Contract #: 04-0120F4Cty: SF/ALA Rte: 80 PM: 13.2/13.9File #: 69.25B**QUALITY ASSURANCE -- NON-CONFORMANCE REPORT****Location:** Changxing Island, Shanghai, P.R. China**Report No:** NCR-000424**Prime Contractor:** American Bridge/Fluor Enterprises, a JV**Date:** 02-Sep-2009**Submitting Contractor:** Zhenhua Port Machinery Company, Ltd (ZPMC), Changxing Island**NCR #:** ZPMC-0398**Type of problem:**

Reference Description: Missed UT indications by QC on SEG060A-011**Description of Non-Conformance:**

Job Name: SAS Superstructure

Subject: NCR No. ZPMC-0398

WELD NUMBER: SEG060A-011

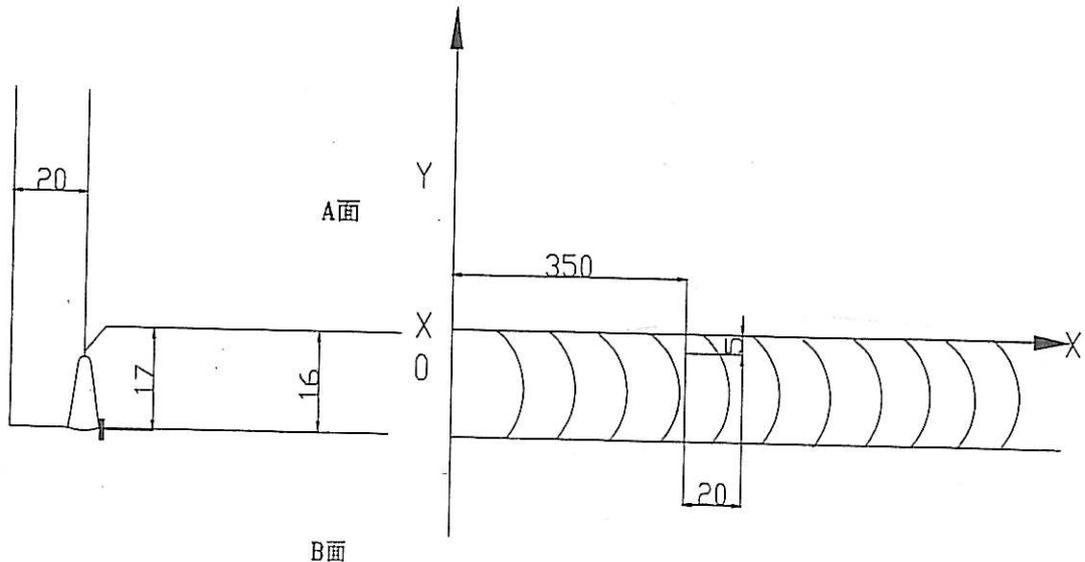
焊缝缺陷描述:

Description of welding discontinuity:

Rejected indication found by ultrasonic inspection is less than the maximum allowance aggregate length.

(UT探伤发现的缺陷总长度小于最大允许长度。) SEG060A-011

1、焊道未及时处理干净。

1. Did not clear the weld pass completely in-time.

1. 从缺陷距离端面较近一侧 ($D \leq 0.65T$, D为缺陷深度, T为板厚) 采用碳刨或打磨的方法去除焊缝缺陷;
2. 参照返修焊接工艺规程 (WPS) 准备正确的接头型式, 预热和焊接;
3. 焊前对修补区域进行VT检测保证缺陷完全被清除;
4. 将修补区域打磨到与母材或邻近焊缝平齐;
5. 根据批准的车间图纸检查焊缝.

1. Gouge or grind from nearer side from metal edge ($D \leq 0.65T$, "D" is depth of defects, "T" is thickness of metal) to remove all defects;
2. Follow repair WPS for joint preparation, preheat, and weld deposit;
3. Verify with VT no defects remain in the weld joint prior to welding;
4. Grind the repaired area flush with base metal or the adjacent weld;
5. Check the welds according to the working drawings.
